Original Arduino Mini Design by Team Arduino
Arduino Pro Mini Design by Spark Fun Electronics

| TITLE: ${PROJECTNAME} | SFE |

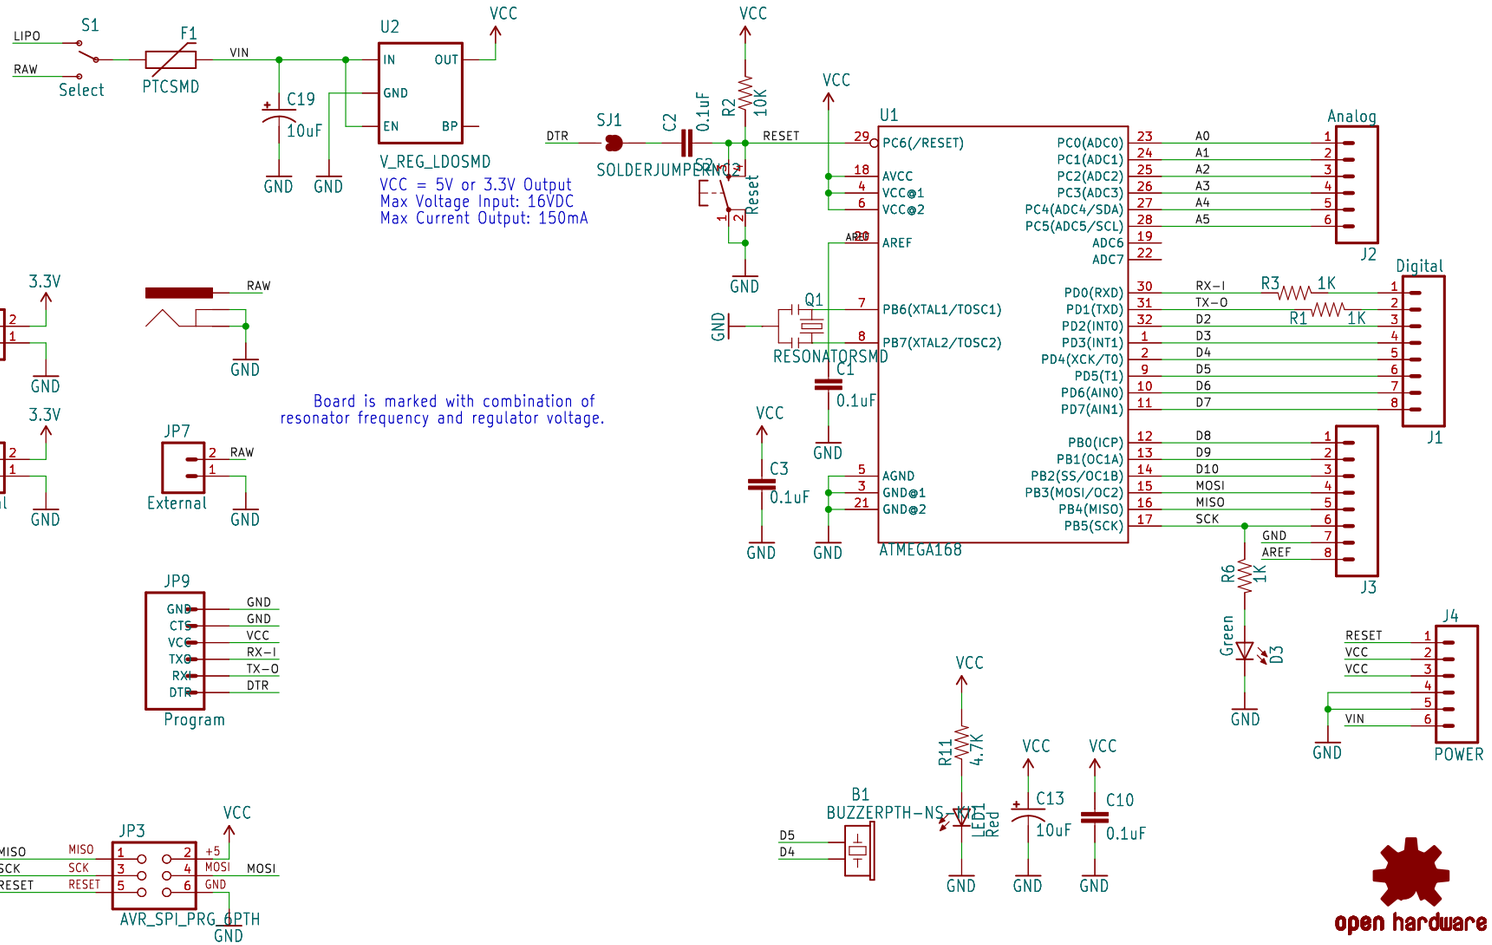
Changes to v14 (date code: 8-24-11)
-updated library to increase annular ring size on all thru-hole pads
(including package change on buzzer PTH
-reposition 6x1 serial header to no longer overhang board
-BOM CHANGE - changes smd slide switch to stronger package with side mount tabs

Changes to v15 (date code: 9-21-11)
-changed package on the Buzzer to not include silk

Changes to v16 (date code: 12-20-11)
-Added OSHW logo
